NTD-NRC-96-4622
DCP/NRC0447
Docket No.: STN-52-003

SUBJECT: WESTINGHOUSE RESPONSES TO NRC REQUESTS FOR ADDITIONAL
INFORMATION ON THE AP600

RAI's addressed in the January 12, 1996 submittal:

TABLE 440.286-1
CMT TEST C064506 - TIME STEP SENSITIVITY STUDY

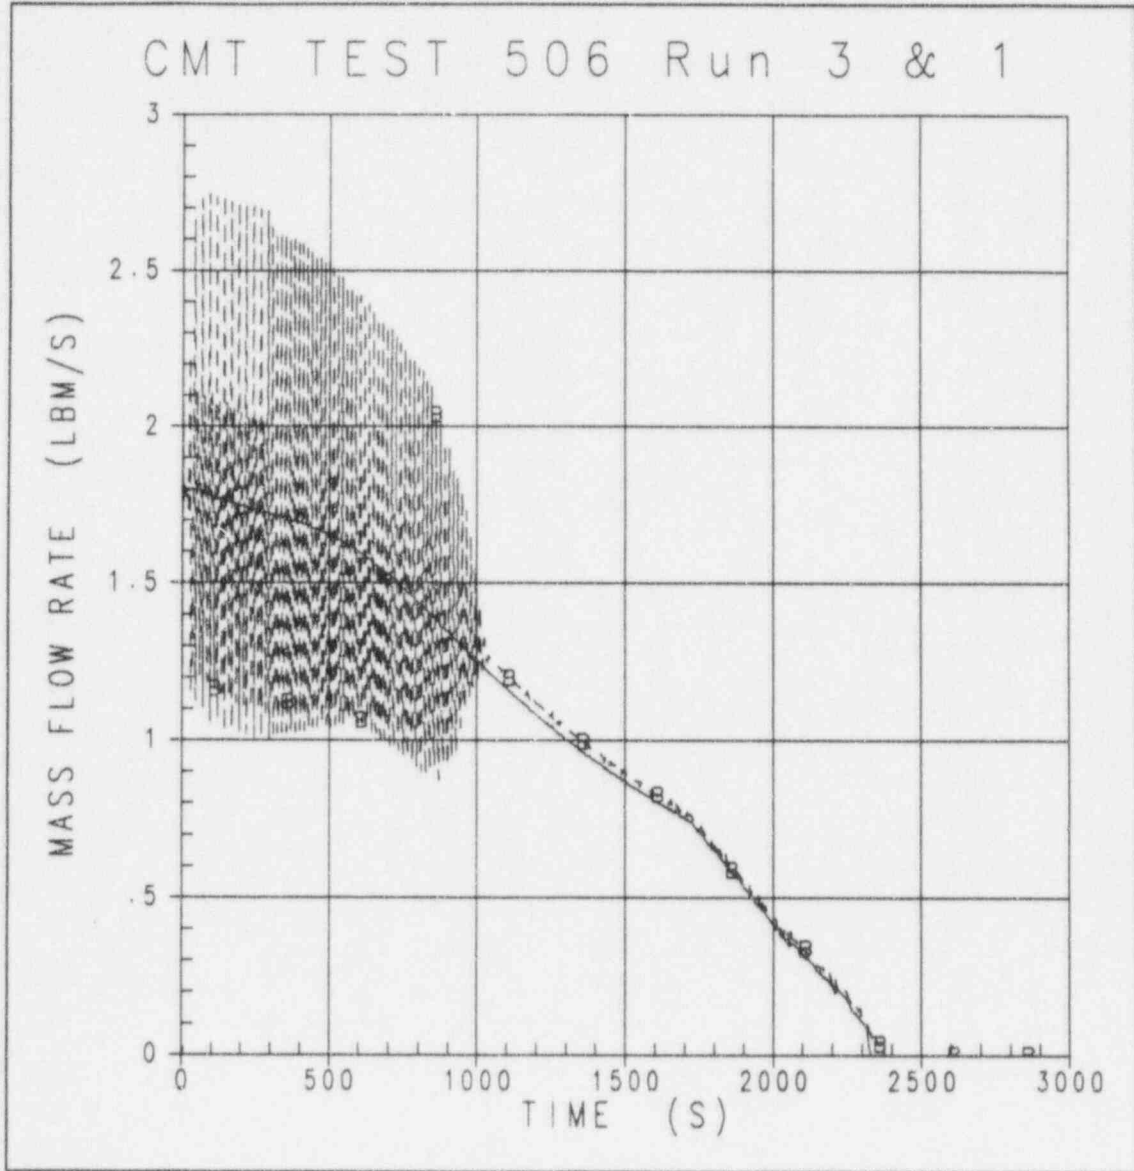
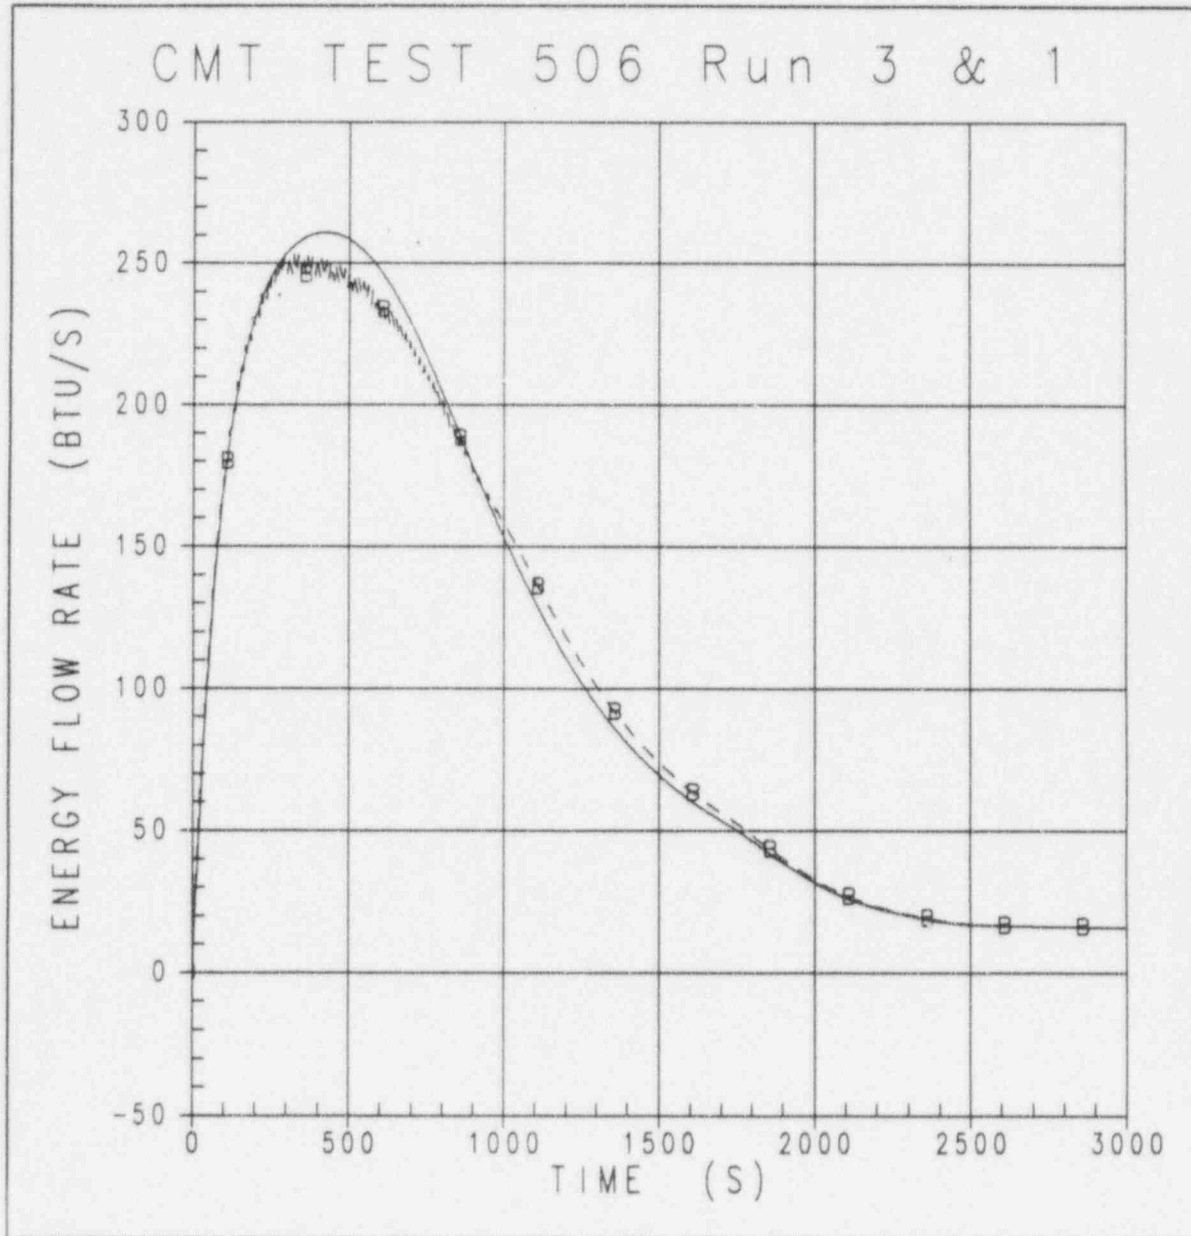
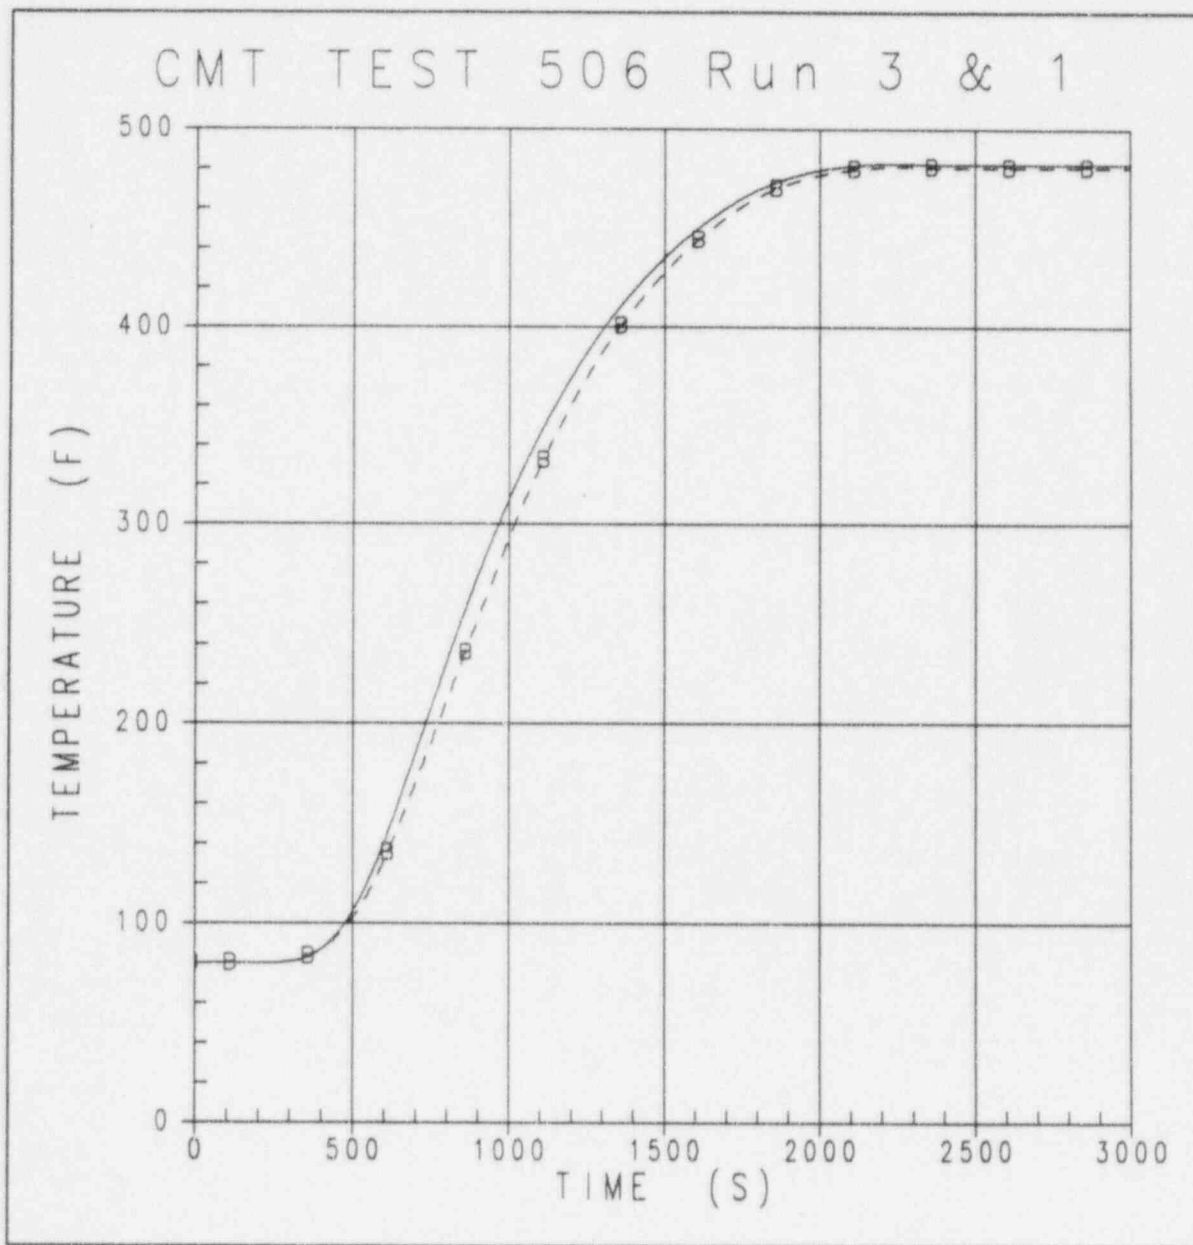
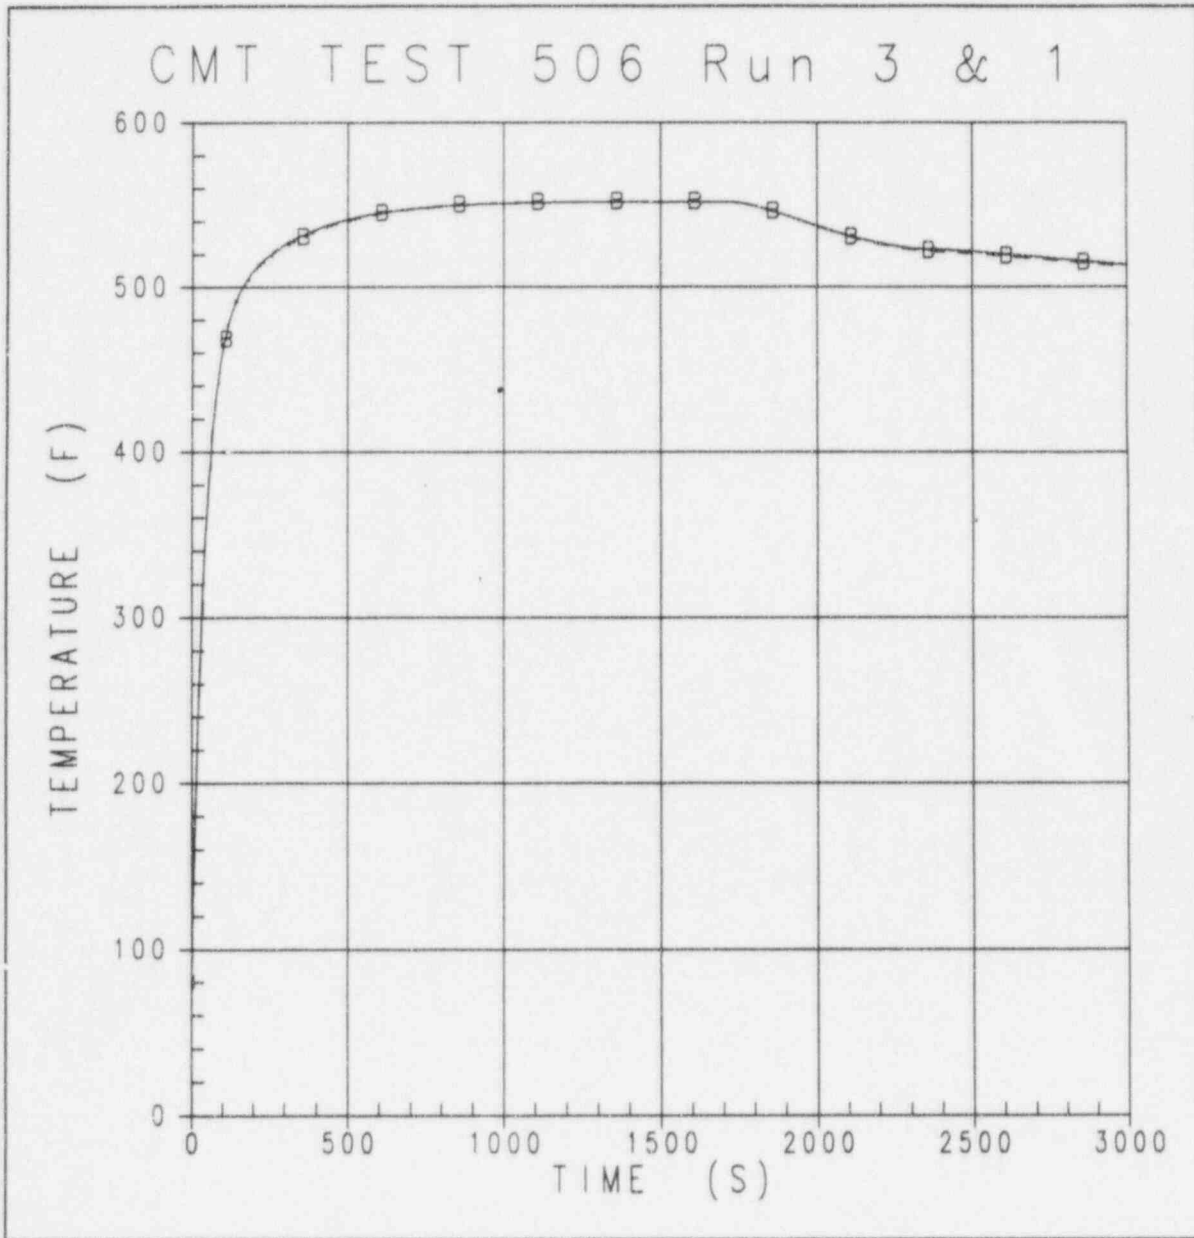
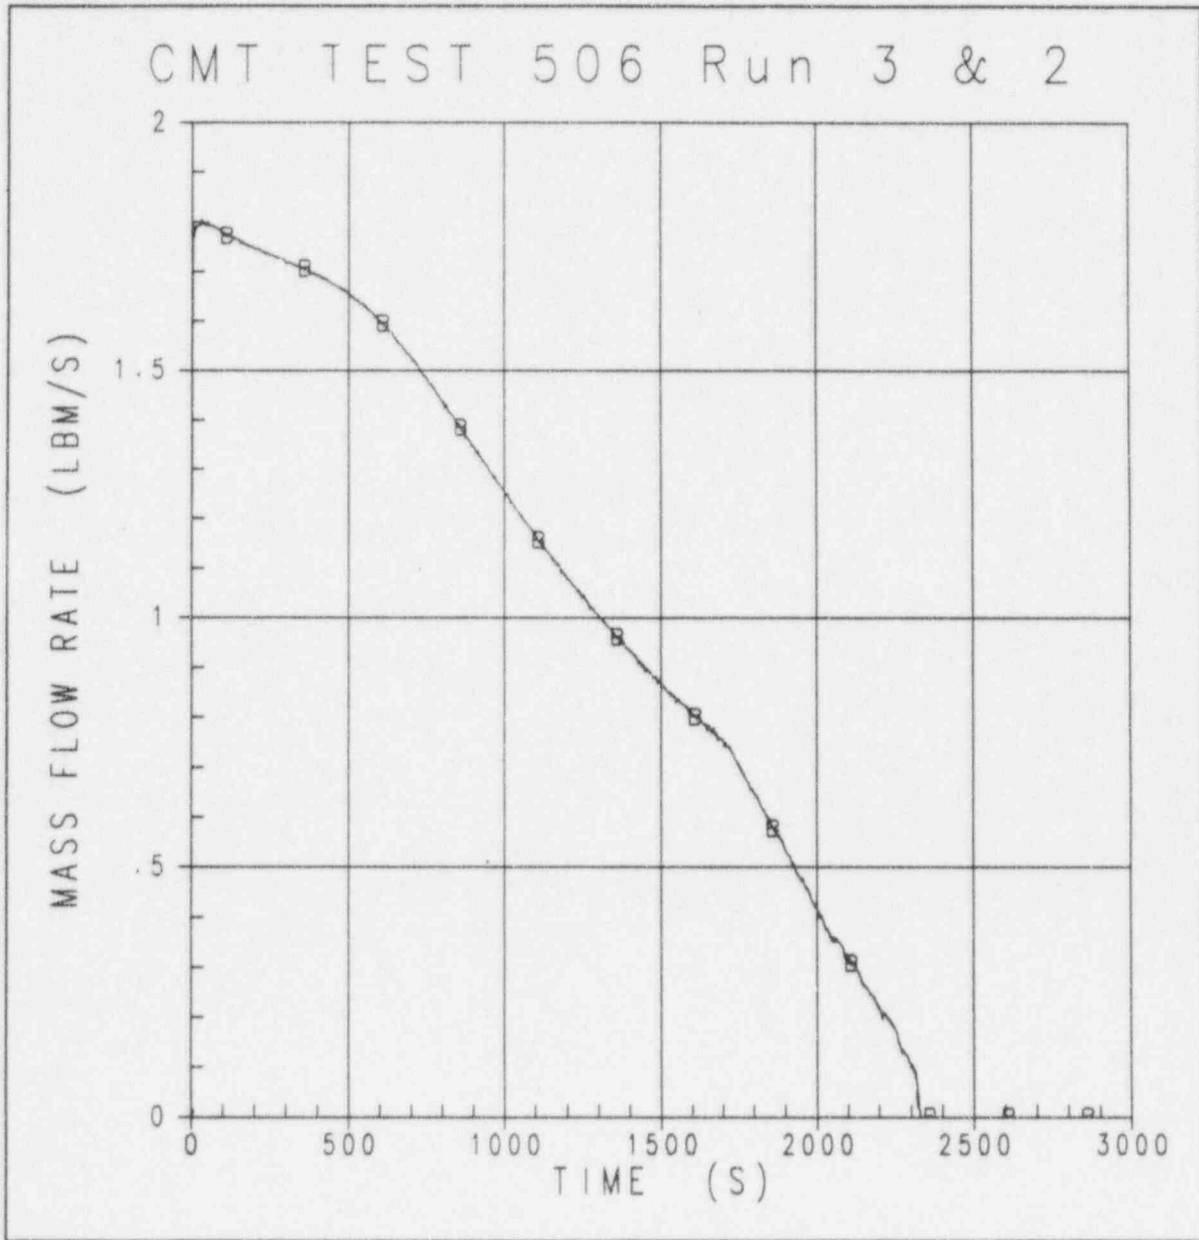
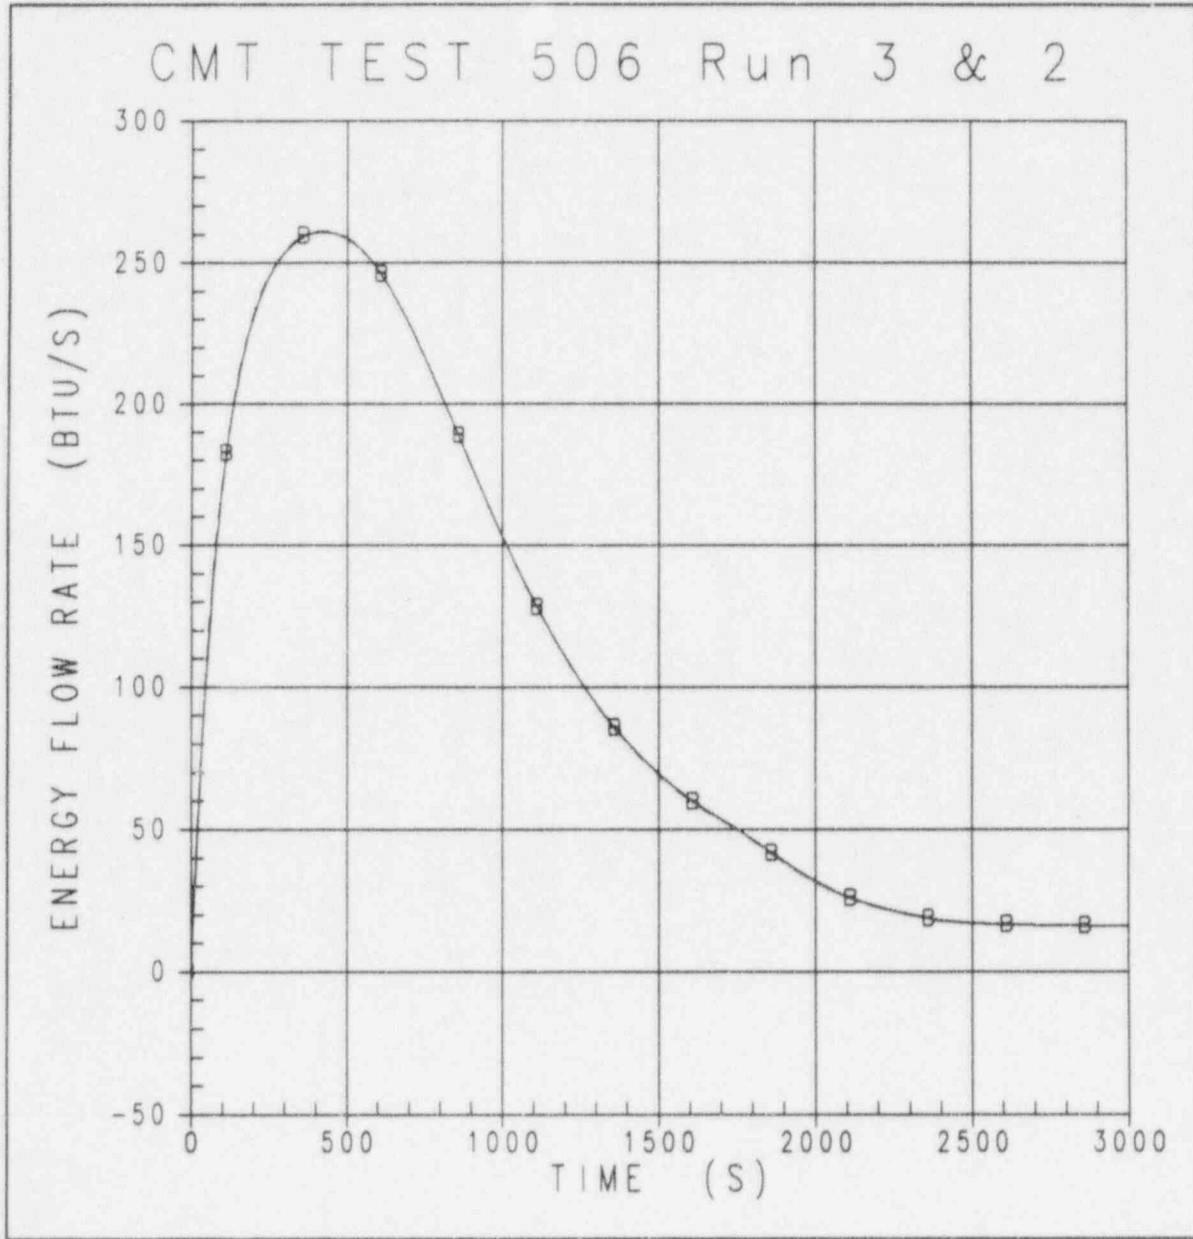
Section 3.1, page 3-1. Please provide a stability analysis of the CMT model that determines the time step bounds for the CMT. Also, please show how the stability of the model is affected by any explicit connection to the RCS.

Figures 440.286-1 through 440.286-12 provide the key parameters for each run. Run 3 is selected as the base case and the other runs are compared to this base case.

The comparison of Run 3 with Runs 2 and 4 (Figures 440.286-5 to 440.286-12) shows that the CMT module response is independent of the CMT time step for time steps less than 2.5 seconds. The plots are superimposed and it is almost impossible to differentiate the results. This demonstrates that the LOFTRAN CMT numerics are stable when used within the acceptable time step range. This is always the case for the AP600 SSAR analyses performed using LOFTRAN-AP or LOFTTR2-AP.

Figure 440.286-1 shows that the CMT model is not stable with a time step of 5 seconds, especially between time zero and 1000 seconds. The injection flow rate oscillates around the solution of run 3. The flow oscillations have a small impact on the other parameters (Figure 440.286-2, 440.286-3, and 440.286-4). This proves that the limiting equation with respect to time step stability is the momentum equation of the lines connecting the RCS and CMTs which is solved explicitly (see response to RAI 440.285).
